SUSQUEHANNA STEAM ELECTRIC STATION
SUPPLEMENT TO PROPOSED LICENSE AMENDMENT
NO. 279 FOR UNIT 1 OPERATING LICENSE NO. NPF-14 AND
NO. 248 FOR UNIT 2 OPERATING LICENSE NO. NPF-22
ARTS/MELLLA IMPLEMENTATION - RESPONSE TO
NRC REQUEST FOR ADDITIONAL INFORMATION
D PLA-6143

Docket Nos. 50-387 and 50-388

Revised Technical Specification Table 3.3.2.1-1 Markups (Deletion of SR 3.3.2.1.4 from Function 1.b)

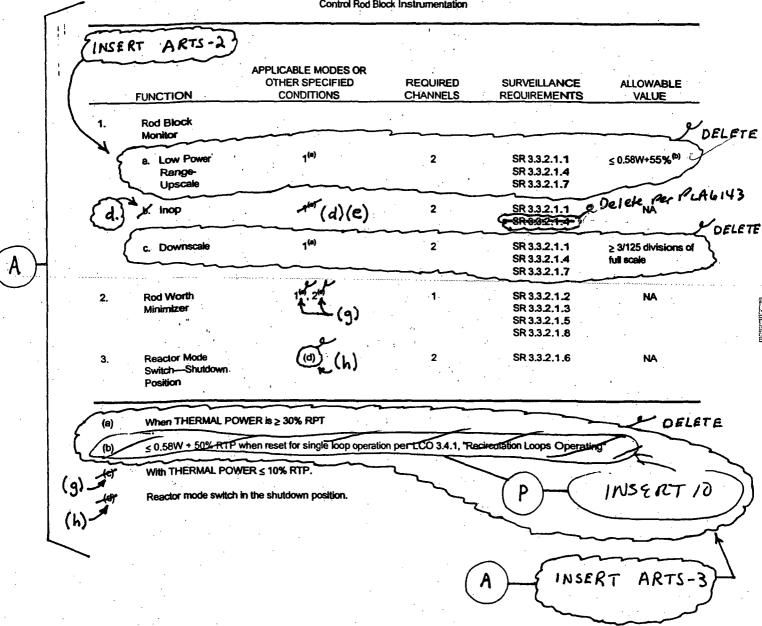
In the Reference 1 submittal, PPL inadvertently failed to delete the applicability of SR 3.3.2.1.4 from the Rod Block Monitor (RBM) Inop FUNCTION in Table 3.3.2.1-1. The SR 3.3.2.1.4 shown in the SSES Unit 1 and Unit 2 Technical Specifications (TS) markups for the RBM Inop FUNCTION in Table 3.3.2.1-1 should have been crossed out.

The current SSES TS, Table 3.3.2.1-1 note "(a)" requires the RBM Inop FUNCTION 1.b to be applicable in MODE 1 at  $\geq$  30% RTP. The SR 3.3.2.1.4 requires verification that the RBM Inop FUNCTION is not bypassed at  $\geq$  30% RTP. This SR is duplicative to the LCO applicability for the RBM Inop FUNCTION. If the RBM Inop FUNCTION is bypassed, it is not capable of performing its function as described in the TS and thus is not OPERABLE. This SR and the LCO Applicability requirement are verified by SSES startup procedures by verifying that the bypass for all RBM functions is cleared at  $\leq$ 30% power.

The SSES ARTS/MELLLA application proposes a revised SR 3.3.2.1.4 and revised Table 3.3.2.1-1 function applicability notes. The revised SR is worded such that the SR excludes the RBM Inop FUNCTION, unlike the current SSES SR. The revised SR is presented in "INSERT ARTS-1" of Reference 1. The revised Table 3.3.2.1-1 function applicability notes are presented in "INSERT ARTS-3" of Reference 1. The new notes that apply to the RBM Inop FUNCTION collectively require the RBM Inop FUNCTION to be applicable at  $\geq$  28% RTP with MCPR less than the limits specified in the COLR.

The SR 3.3.2.1.4 is not required to be applied to the RBM Inop FUNCTION by the NUREG or the NRC-approved NEDC since the RBM Inop FUNCTION is required by the LCO Applicability (Table 3.3.2.1-1 function applicability notes) to be OPERABLE at the power levels required by the RBM to perform its protective safety functions. Inclusion of an SR in TS to verify that an LCO Applicability requirement is met is not required nor is it part of the NUREG format, and thus inclusion of an SR of this type provides no added assurance of safety.

The revised TS markups showing the deletion of SR 3.3.2.1.4 for the RBM Inop FUNCTION in Table 3.3.2.1-1 are attached.

•		·	·	
INSERT ARTS-2	APPLICABLE MODES OR OTHER SPECIFIED CONDITIONS	REQUIRED CHANNELS	SURVEILLANCE REQUIREMENTS	ALLOWABLE VALUE	•
1. Rod Block Monitor					DEET
E. Low Power Range- Upscale	144	2 .	5R 3.211 5R 3.214 5R 3.3217	≤ 0.58W+55% M	•
Ed 7 stc trop	14 (d)(e)	2	SR33211 Deleke	PERMICA 6143	ا محلا صو
c. Downscale	7	2	5R33211 5R33214 5R33217	2 8/125 divisions of full scale	5
2. Rod Worth Minimizer	(4)		5R33212 5R33213 5R33215 5R33218	NA.	
8. Reactor Mode Switch— Shutdown Position	OE (h)	2	6R 3.3.2.1.5	NA	
(a) When THERMAL POWER	k 2 80% FRPT			- Pe De	LETE
		or bor LCQ 3/1	Recirculation Loope Oberating	2	
(g) With THERMAL POWERS			Iv:	ERT 10	e des
(K) 2		P	MIERT	Arcrs-3	· ·.
			h	ممه	
				(A)
